**BEFORE THE PUBLIC UTILITY COMMISSION**

Docket No. LC 83

CASCADE NATURAL GAS,

Staff Opening Comments

Figure 2: Comparison of Company Deschutes Forecast with Portland State University

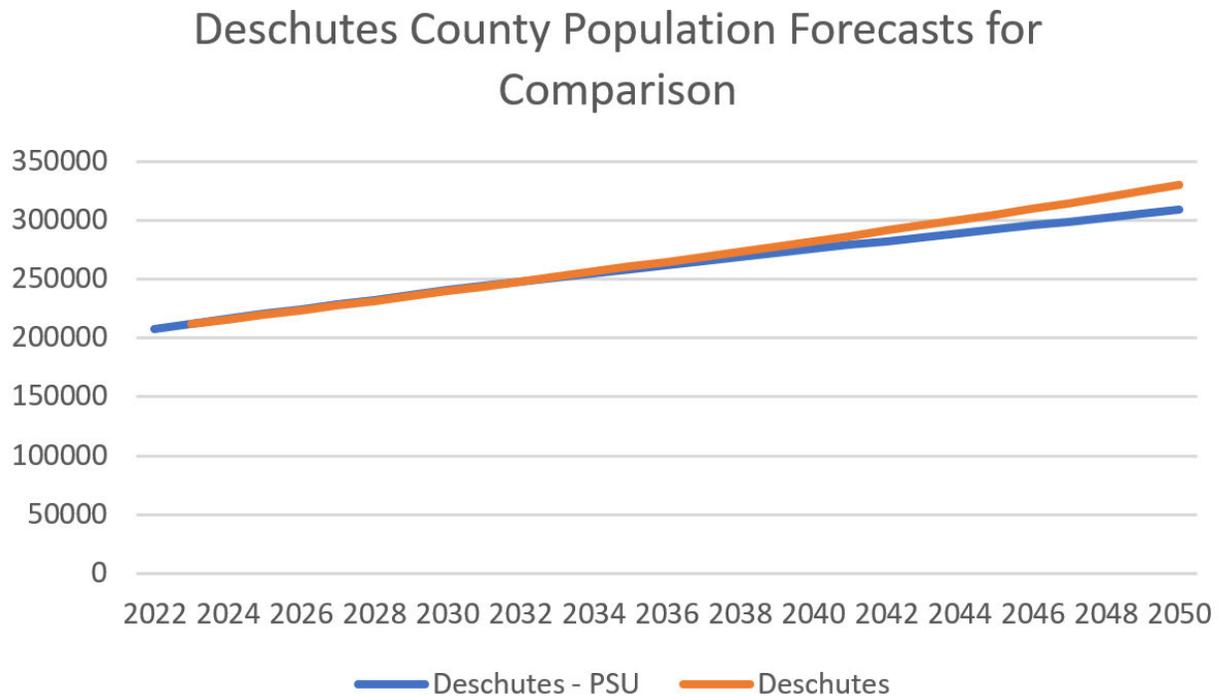
Staff notes that employment forecasts from the Population Research Center (PRC) at Portland State University (PSU) vary meaningfully from the Company’s population forecasts furnished by Woods & Poole (W&P).<sup>15</sup> The PRC and W&P population forecasts may be compared by measuring the mean absolute percent deviation (MAPD) between the forecasts. Baker, Malheur, and Umatilla counties have MAPDs of 5.0, 15.5, and 3.9 percent respectively over each 2023-2050 forecast series, with the W&P forecast being the lesser of the two population forecasts. The absolute percent difference by year for Deschutes County is less than 1 percent for the years 2022-2035 but grows to 6.3 percent by the year 2050 with the W&P forecast being the larger of the two forecasts. The MAPD for Deschutes County for the 2022-2050 forecast horizon, comparing only the published forecast years from the PRC, is 2.4 percent.

These differences are likely the result of methodology and assumptions relied upon for each forecast series and deserve additional scrutiny before the next IRP. The differences in the Deschutes data are relatively small, possibly contributing to an overestimation after 2040. The differences in Baker, Malheur, and Umatilla counties, however, are relatively large, and may lead to a persistent underestimation of demand in eastern Oregon.

Figure 3: Comparison of Company Baker, Malheur, and Umatilla Forecast with Portland State University

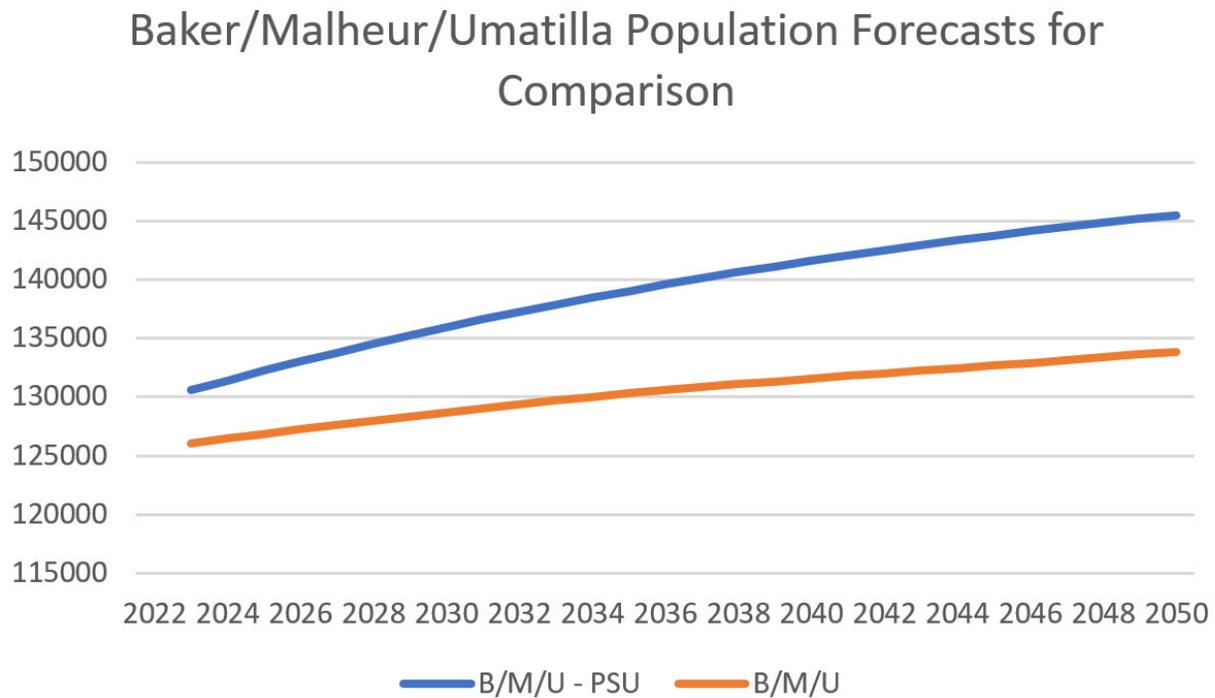
Staff finds the 2023 IRP provides an insufficient amount of discussion for this other demand forecast. In Reply Comments, Cascade should explain why a separate demand forecast was used in Synergi, rather than exogenously entering the demand forecast described in Chapter 3. The Company should also compare the results of the two demand forecasts in this IRP for Prineville, Baker City, Ontario, and the aggregate for the Company’s Oregon service territory.

Figure 4: Linear Fit using 65 Degrees, Figure 3-2 from the 2020 IRP

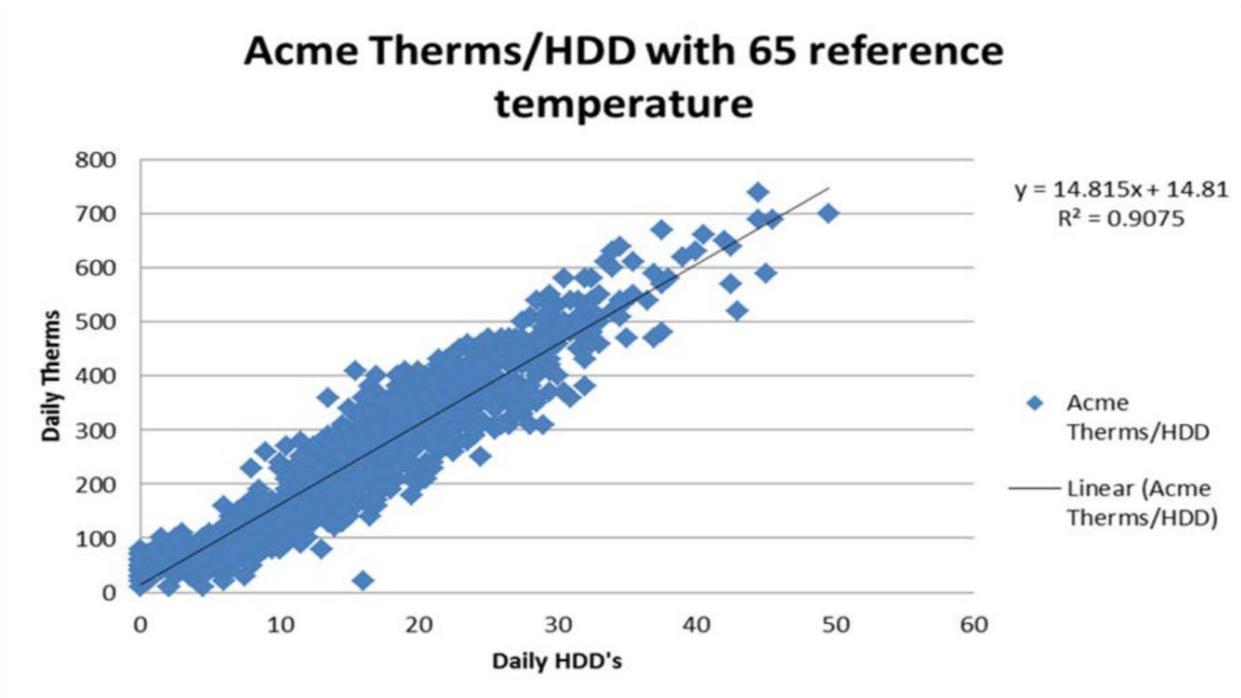
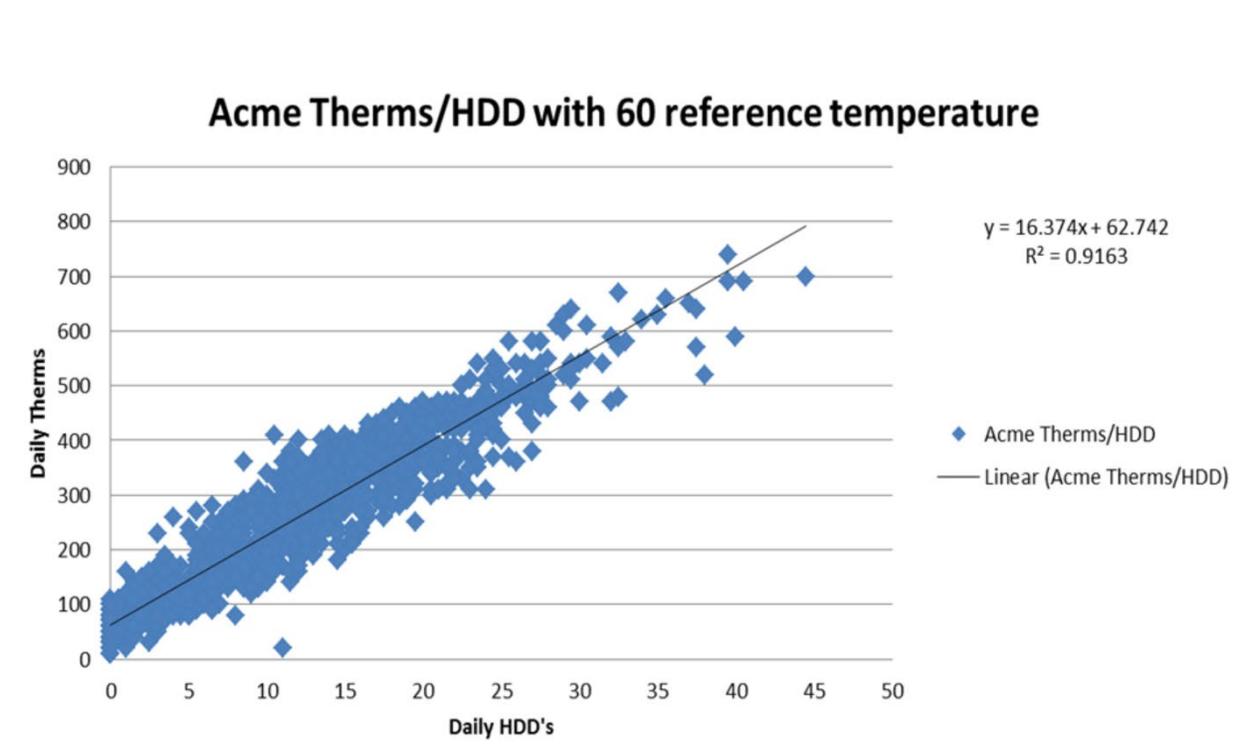
In addition to the choice of historical temperature for the design day model, Staff questions Cascade's recalibration of the definition of a heating degree day away from industry standard of  $65^{\circ}$ . The Company applies a deterministic approach to estimating demand at the design day temperature by deriving a linear relationship between observed HDD and demand volume (in daily therms). By extrapolating the resulting line, the estimated demand volume can be determined at the peak day HDD. However, the Company uses a  $60^{\circ}$  F threshold to define the HDD rather than the industry standard of  $65^{\circ}$  F. Cascade justifies this recalibration by contrasting the linear relationship of both temperatures. The use of  $60^{\circ}$  has a slightly better correlation as shown by comparing Figures 4 and 5 below.

Staff agrees with Cascade that the overall fit of this linear model using 60° is slightly better with an R<sup>2</sup> of 0.9163 compared to 0.9075. However, that very small difference in fit is not the best metric to determine the accuracy of the HDD calibration. At low temperatures, the 60° model's error skews significantly to overestimation while the industry standard 65° is demonstrably more accurate at lower temperatures by having a more balanced rate of error between overestimation and underestimation. Using an HDD threshold of five degrees less increases the slope of the line by ten percent while improving the fit of the model by only one percent. Cascade's recalibration has increased the number of observations at high temperatures (low HDD), which skews the average away from the impacts of lower temperatures (high HDD), the very temperatures Cascade is trying to extrapolate. A qualitative description of why Cascade's recalibration has made this linear model less accurate is that at extremely low temperatures (high HDD), many customers' intake of gas can be maxed before temperatures reduce even further to the extremely low outlier level (highest observed HDD level in 30 years) that Cascade is trying to estimate. Staff finds Cascade's use of an alternative HDD definition unreasonable because it likely overestimates demand at extremely low temperatures.

***Recommendation 7: Staff recommends, in Reply Comments, Cascade provide Synergi results for Prineville that use the lowest temperature in the past 30 years and an industry standard heating degree day calibration of 65 degrees Fahrenheit.***

Figure 7: Cascade's Oregon Preferred Resource Strategy

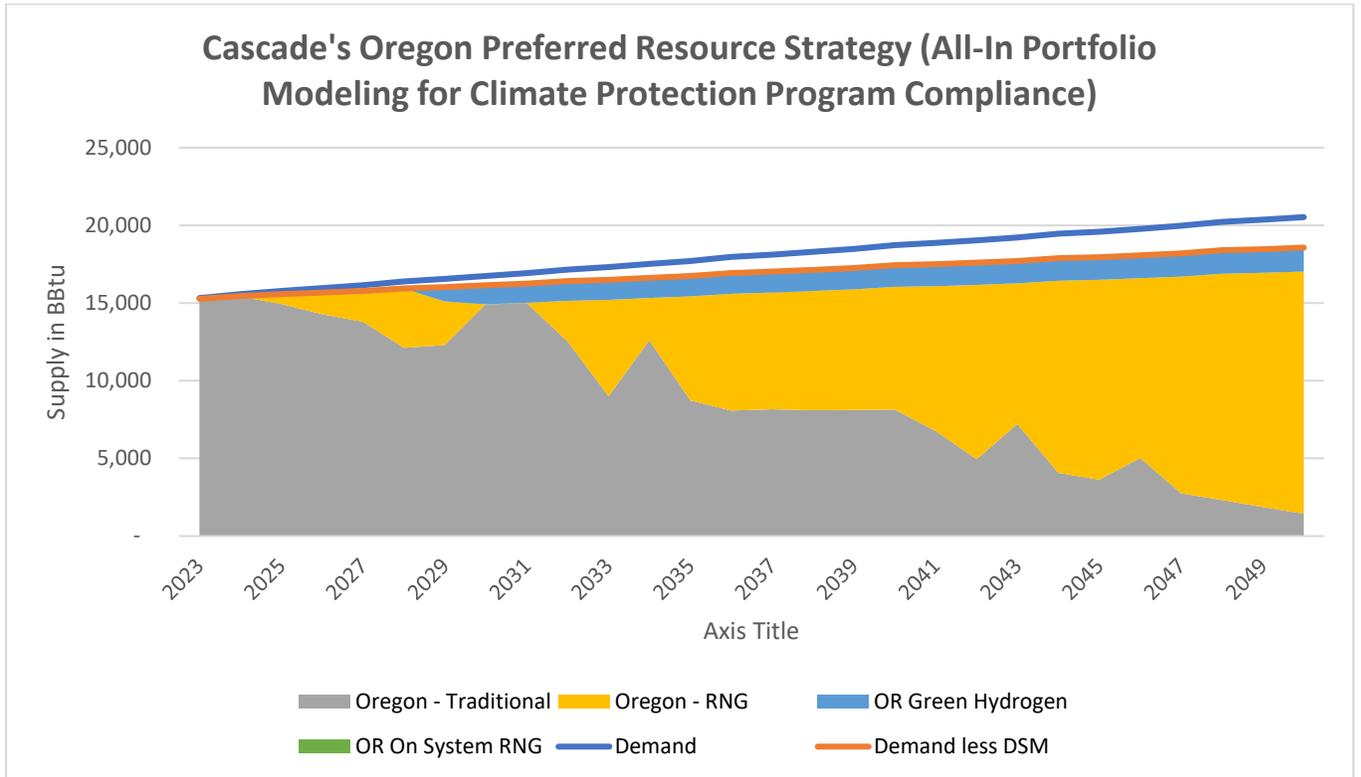
Cascade’s expected costs for green hydrogen show significant decreases through 2050. Cascade projects that green hydrogen costs will fall from \$18.44/Dth in 2025 to \$5.63/Dth in 2045. Recent studies and legislation provide some insight into the possible future cost trajectories of these technologies, and the accuracy of Cascade’s estimates.

Staff is concerned that Cascade's plan for the inclusion of green hydrogen is too near-term. Cascade's Oregon PRS shows green hydrogen as part of its portfolio in only six years. This is concerning considering the cost and availability assumptions appear to be derived from a single article, which lacks the necessary detail to support the assumptions used. Staff recommends Cascade provide in Reply Comments the price and availability ranges used in Monte Carlo analysis, any net present value revenue requirement (NPVRR) analysis it conducted to measure the severity of bad outcomes associated with missing green hydrogen targets, and how those sources translated into the Preferred Resource Strategy and Figure 4-5.

***Recommendation 15: Staff recommends, in the next IRP, Cascade provide all supporting documentation it relied on regarding green hydrogen market development in the United States; price and availability ranges used in Monte Carlo analysis; and any NPVRR analysis it conducted to measure the severity of bad outcomes associated with missing green hydrogen targets, and how those sources translate into the Preferred Portfolio.***

Figure 8: Comparison of Renewable Supply-Side Resource Cost Trajectories

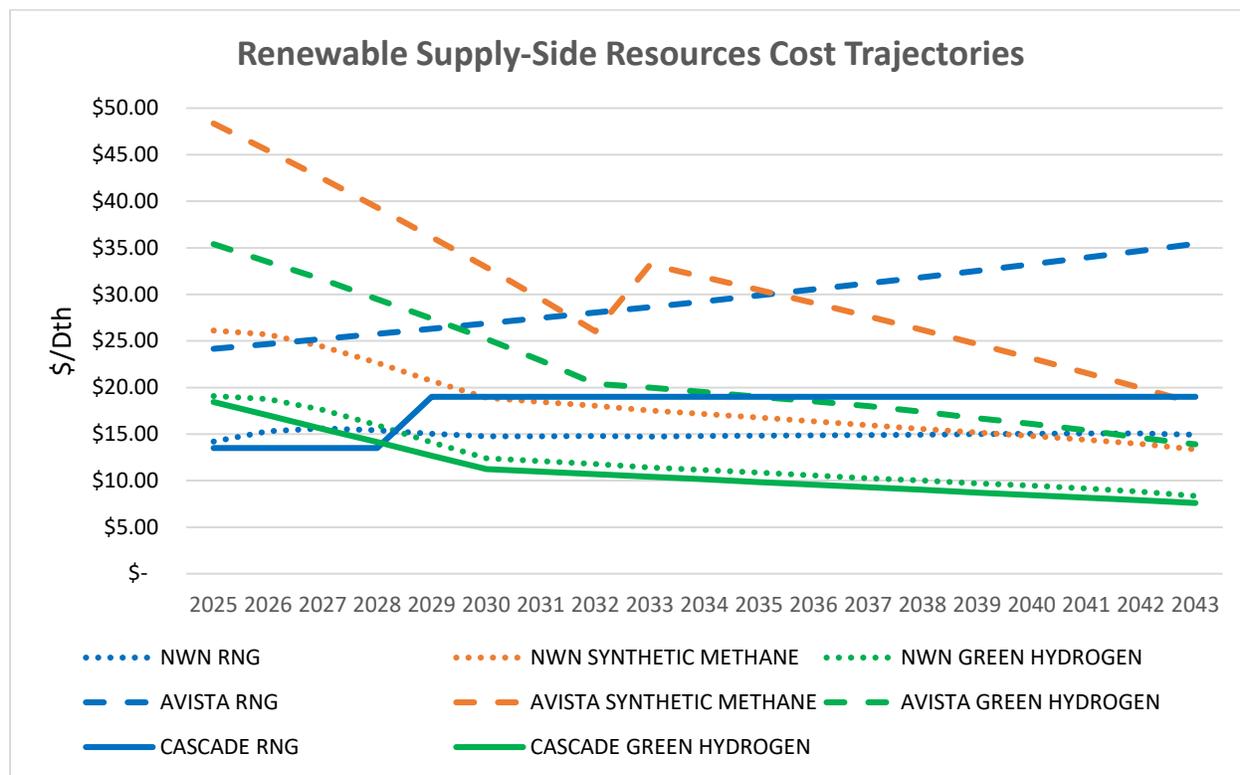
Cascade’s assumed cost trajectories can also be compared to other Oregon natural gas utilities’ cost trajectories based on recent IRP filings. After reviewing both NW Natural and Avista’s most recent cost projections for all new supply-side renewables, not just green hydrogen, Cascade’s projections appear optimistic, particularly regarding the cost of green hydrogen. These are demonstrated in the Staff generated chart below.

Overall, Staff has concerns surrounding Cascade’s green hydrogen cost assumptions. There are also serious questions surrounding the resource’s ability to be produced on a large enough or cost-effective scale. And, while Cascade’s Action Plan states the Company’s intentions to investigate the cost and feasibility of a potential hydrogen plant and other hydrogen options as an alternative resource, Staff is concerned with Cascade’s current projections given the costs are derived from a single-page article.<sup>40</sup>

Figure 9: Difference between Cascade's Base and High Avoided Cost Assumptions

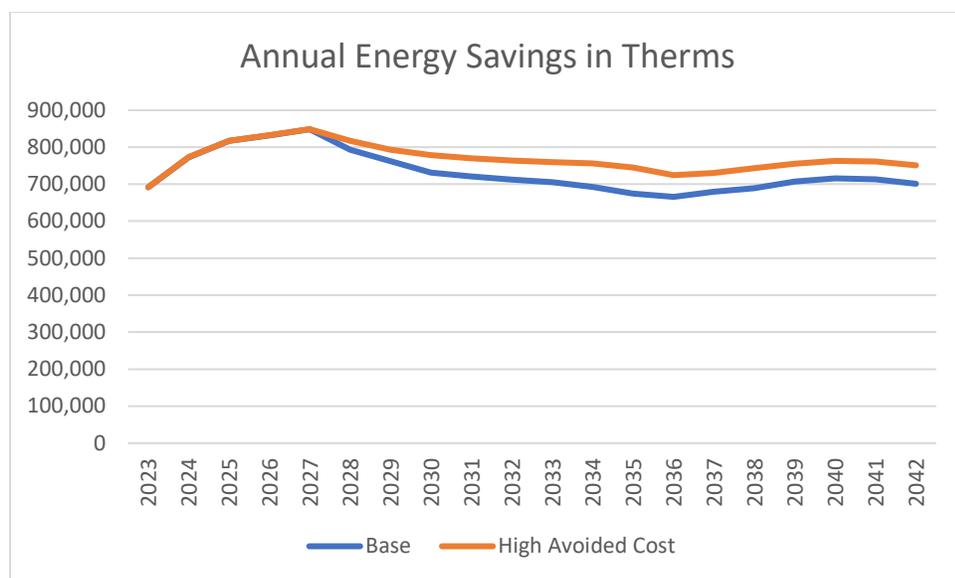
The difference in avoided costs to Energy Trust’s base case and the high avoided cost assumptions ultimately has a relatively limited impact on gross savings in therms.

Visible savings do not appear until 2027. So, the impact would not be expected to be material to the reasonableness of this IRP’s Action Plan. This mimics the general limit to near-term deployment of DSM.

While the savings are modest, they may still be material to long-term resource selection in PLEXOS. Since these higher avoided cost assumptions are known to be more accurate, and the Company has already received results from Energy Trust, Cascade should have used these high avoided cost assumptions as the reference planning assumption. Doing so may have eliminated or delayed the selection of hydrogen as a resource.
